Project SNM-8
Eocket 70-36

Subject: Mullinckrodt Chemical Works

We have reviewed the letter of December 10, 1958, from Mullinckrodt Chemical Works, requesting amendment of ~~the~~ License No SNM-33 to permit pelleting operations on uranium enriched to 5% U-235 in a new facility at Hematite, Missouri.

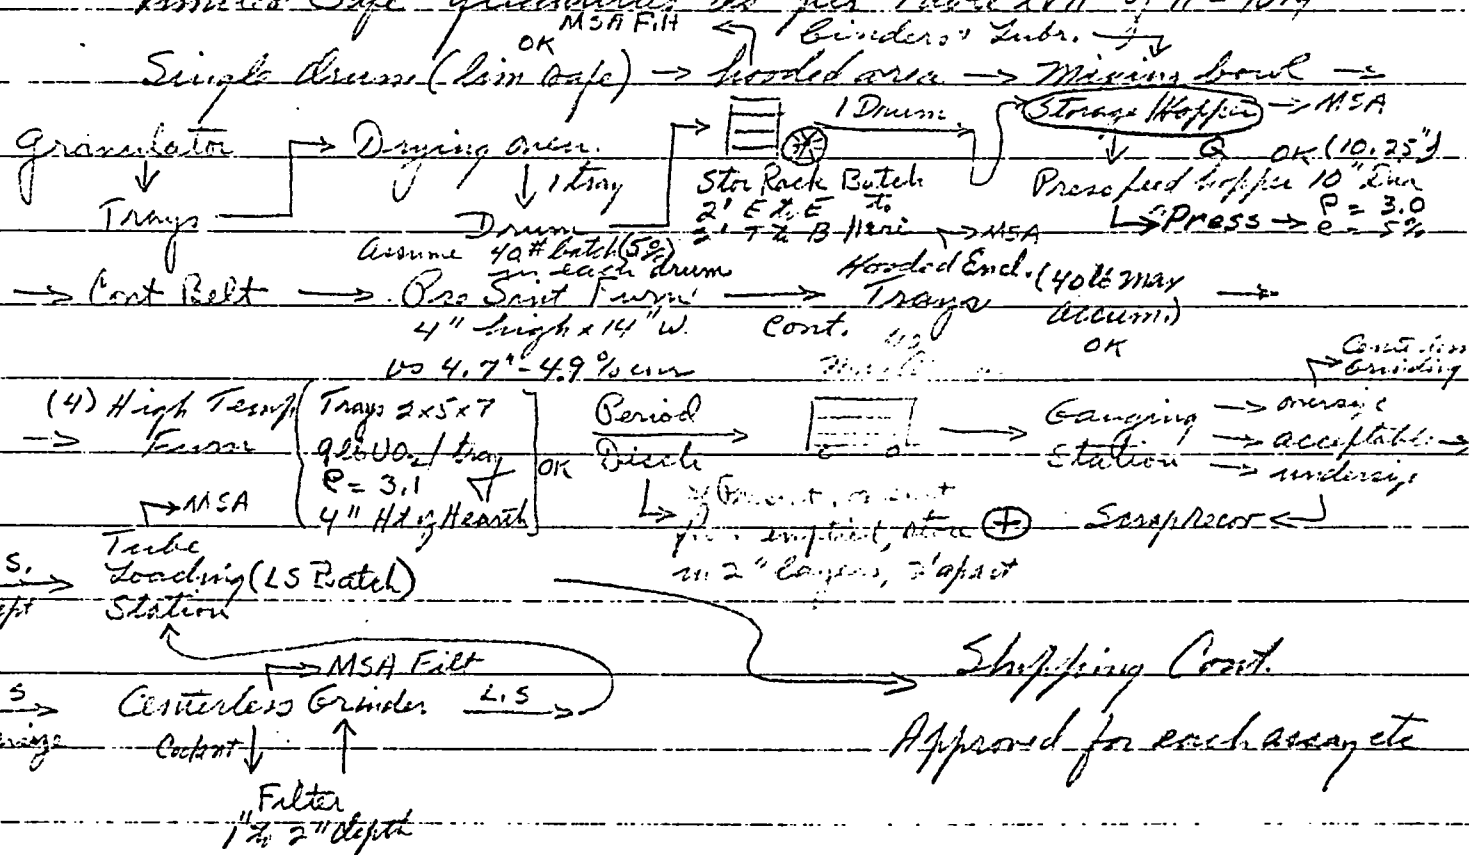
"Limited Safe" quantities as per Table XVII of K-1019

Bldg. Fireproof + rad. monitor

⊕ 2' top + bottom land 2' edge to edge - OK in comp with 18" a. (Note: 40 x .88 x 4.4 = 16,000 g U. 235 ÷ 3.1 = 5176 cc ÷ 16.4 = 315 m)

⊕ 2" layers 2' apart, 1/2" dup = 158 m² (12" x 13")
